APPLICATION NO.	FILING DATE	FIRST NAMED INVENTOR	ATTORNEY DOCKET NO.	CONFIRMATION NO.
10/567,404	02/06/2006	Masahiko Igarashi	025416-00025	2541
4372	7590	11/01/2007	EXAMINER	
ARENT FOX LLP			GARCIA, ERNESTO	
1050 CONNECTICUT AVENUE, N.W.			ART UNIT	
SUITE 400			PAPER NUMBER	
WASHINGTON, DC 20036			3679	
			NOTIFICATION DATE	DELIVERY MODE
			11/01/2007	ELECTRONIC

Office Action Summary

DETAILED ACTION

Fig. 1

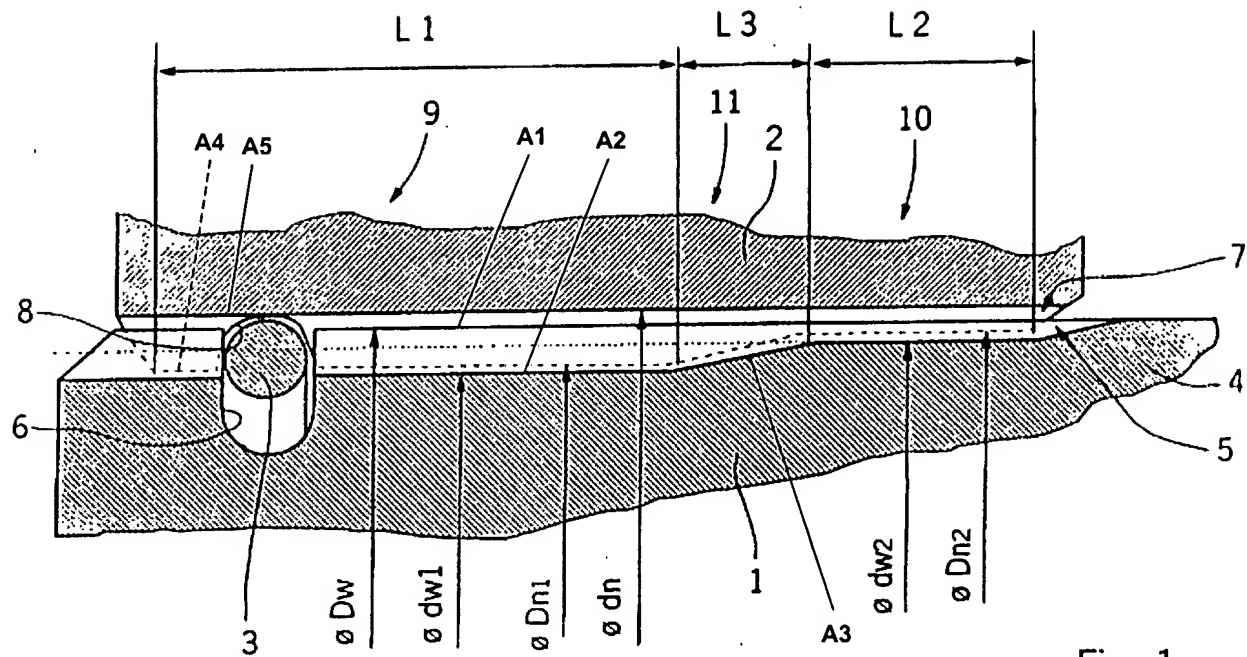
Regarding claim 11, Beigang discloses, in Figure 1, a mechanism comprising a shaft 1 and a hub 2. The shaft 1 has a shaft tooth section 5. The hub 2 has a hub tooth section 7 in engagement with the shaft tooth section 5. The shaft tooth section 5 has a straight peak A1 (see marked-up attachment) having a constant tooth thickness and a valley A2 having an outside diameter varying from an end of the shaft 1 toward a shaft shank 4 of the shaft 1. The valley A2 has a step region A3 raised toward the hub tooth section 7 obliquely at a predetermined angle. The hub tooth section 7 has a straight peak A4 having a constant tooth thickness and a valley A5. The peak A4 of the hub tooth section 7 and the valley A5 of the hub tooth section 7 have constant inside diameters from the end of the shaft toward the shaft shank 4 in an axial direction of the shaft 1.

Regarding claim 12, the step region **A3** has a tilt angle set to a value ranging from 5 degrees to 45 degrees.
